N1060A-03

Information Only Service Note

N1060A 50/85 GHz Precision Waveform Analyzer

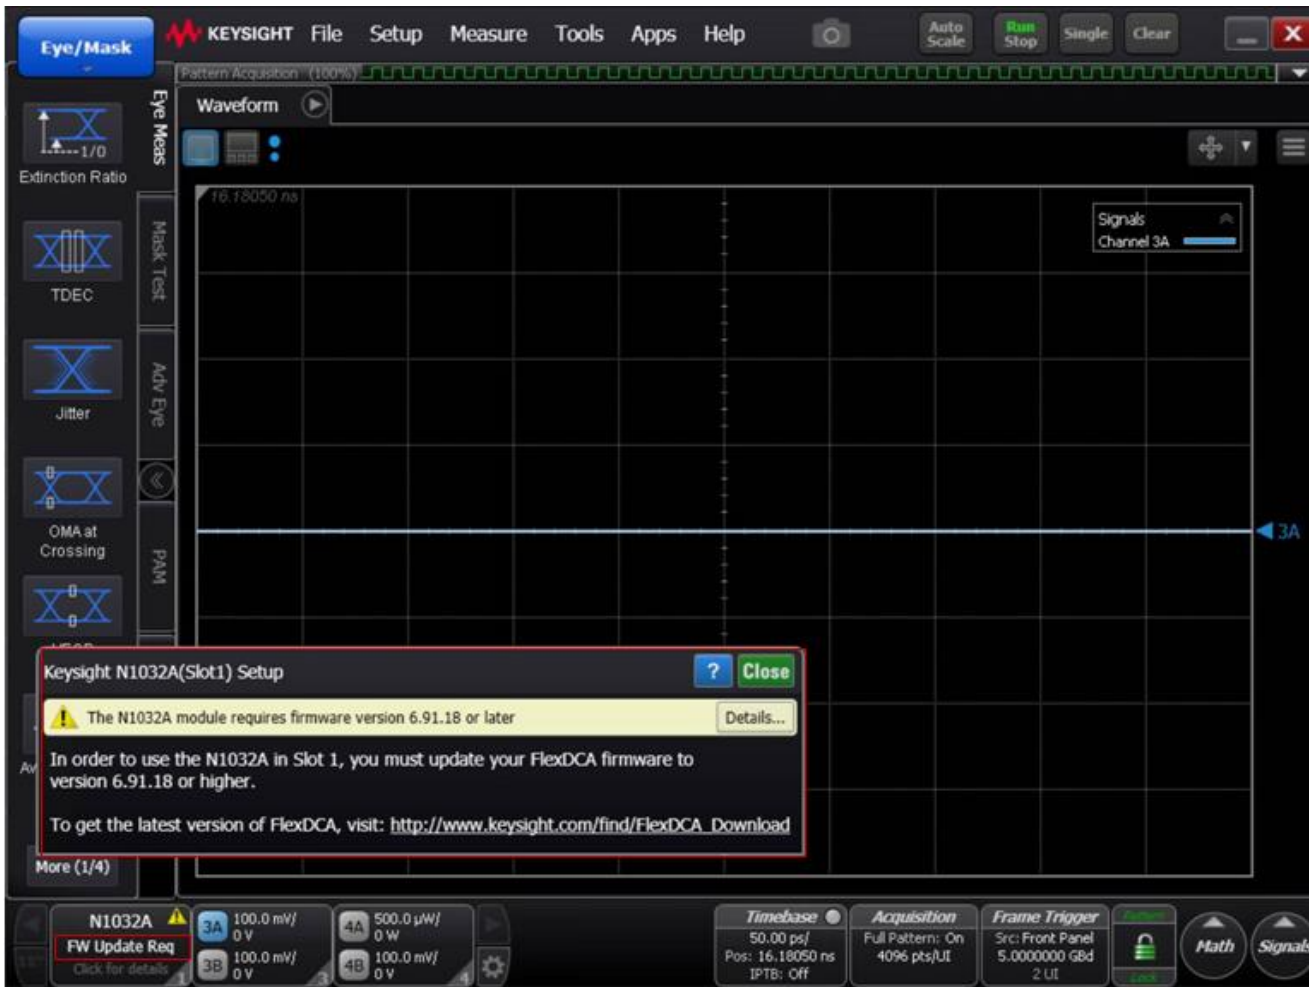
A message will be displayed in FlexDCA if a newer version is required.

With the module installed in a DCA mainframe, if a message like the one below is displayed, FlexDCA must be updated to the indicated version (or later):

To update FlexDCA software, download from www.keysight.com/find/flexdca_download and install. While only the indicated version is required, updating to the latest version is recommended.
